Date: May 19, 2022 JN: 13522.001

Re: Kittery Aroma Joes | Site Plan Peer Review Comments

Haley Ward, Inc. (Haley Ward) has prepared the following response to the review comments on the 523 US Route 1 Aroma Joes development, provided by Jodie Strickland (CMA Engineers) on April 19, 2022. The comments have been provided in bold italics, followed by our response.

TYPICAL ROADWAY/SIDEWALK BUILDUP DETAIL
N.T.S.

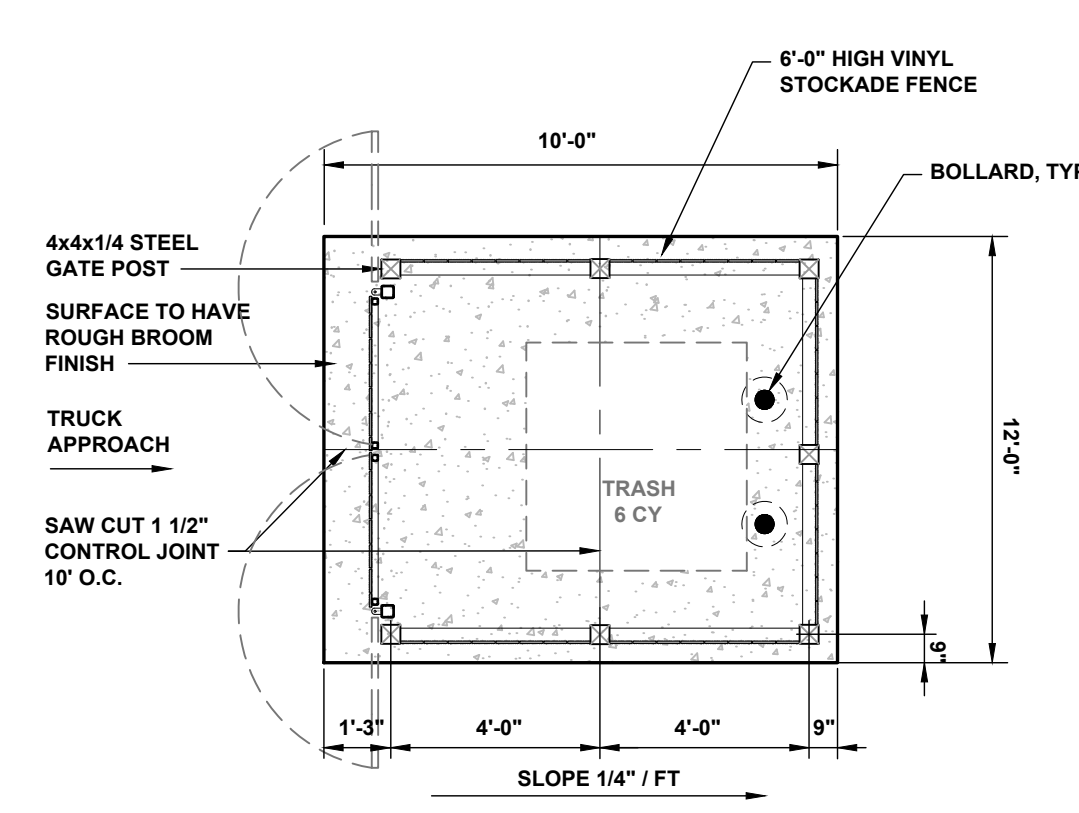
- 2. Discussion of sidewalk installation was part of the MDOT scoping meeting and consequently, the applicant has added a proposed sidewalk on site. Details of the sidewalk should be provided.*

A detail of the proposed sidewalk has been provided on the Detail Sheet.

TYPICAL WATER SERVICE DETAIL
N.T.S.

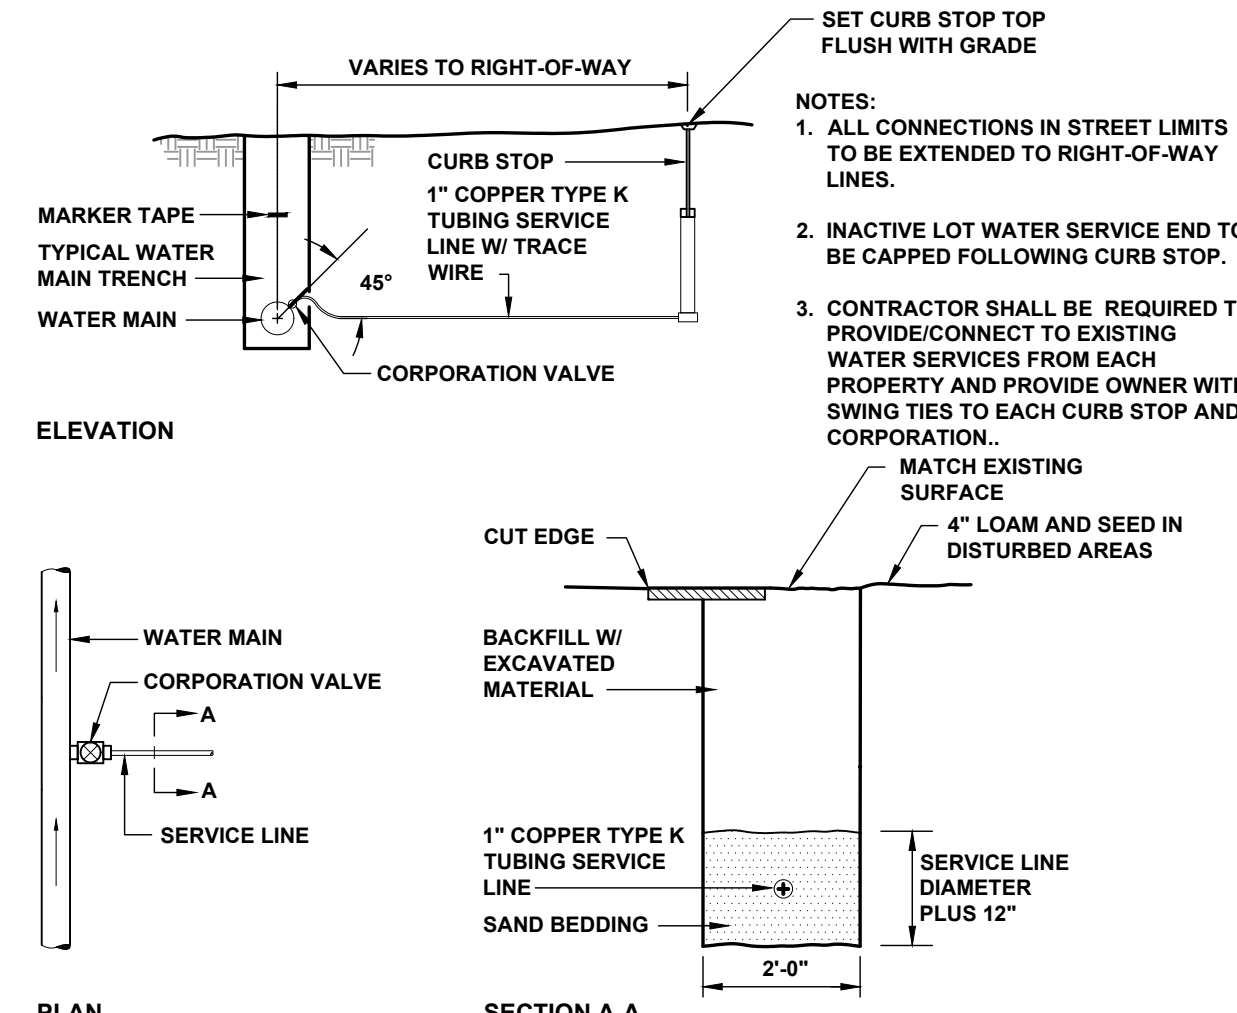
- 3. The plans should provide details for the water service (size, material, bedding, curb stop, etc.)*

A detail of the proposed service has been provided on the Detail Sheet.

TYPICAL SEWER TRENCH DETAIL
N.T.S.

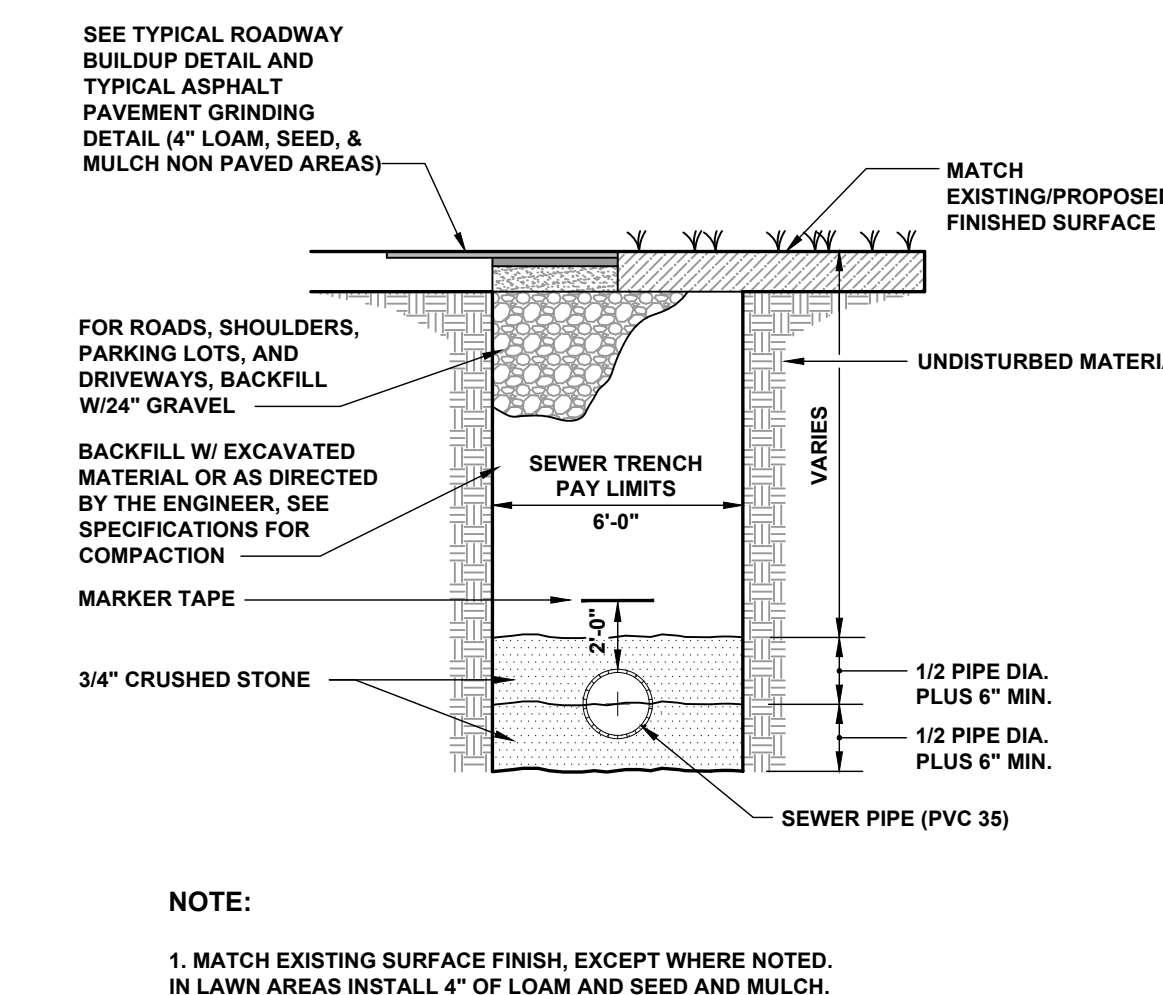
6. *The plans should provide details for the sewer service (size, material, bedding, etc.)*

A detail of the proposed service has been provided on the Detail Sheet.

PROPOSED SITE PLAN

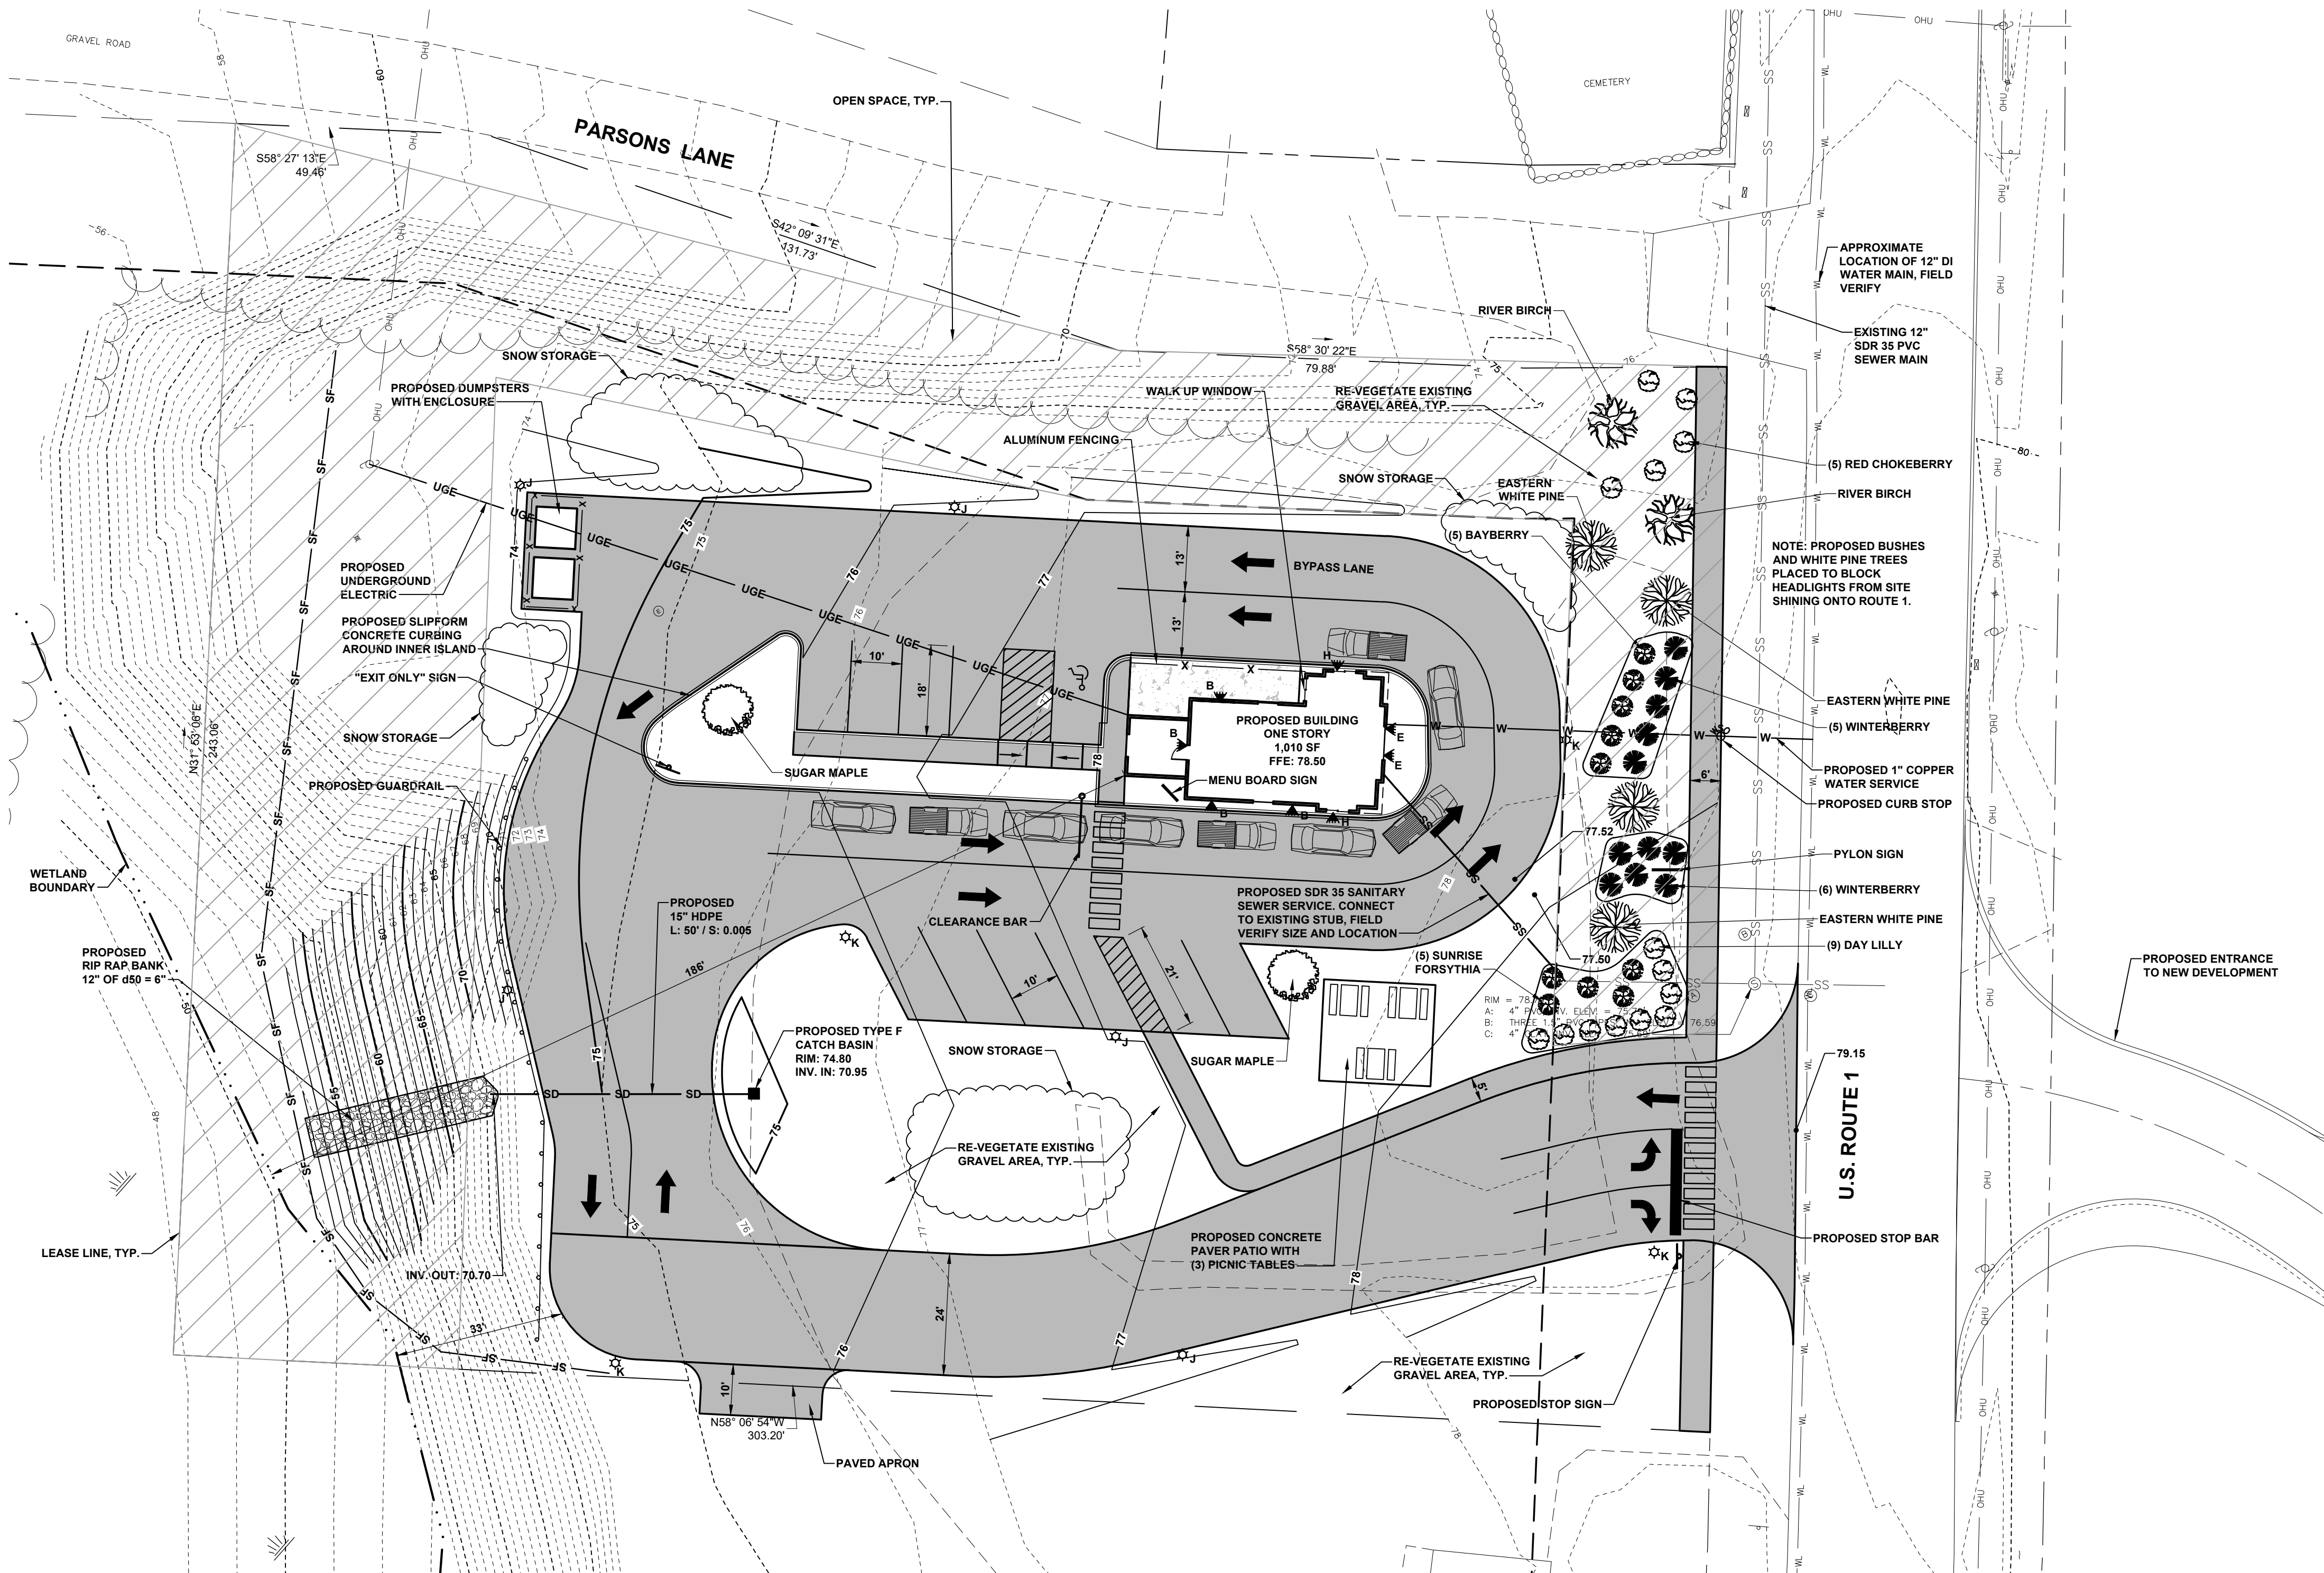
2. *The applicant should add the pre and post development impervious area numbers to the plan.*

4. *Please add snow storage areas to the site plan and note that snow will be removed from the site if the storage areas become full.*

The attached revised site plan includes these numbers in the project summary table.

Please refer to the attached revised site plan.
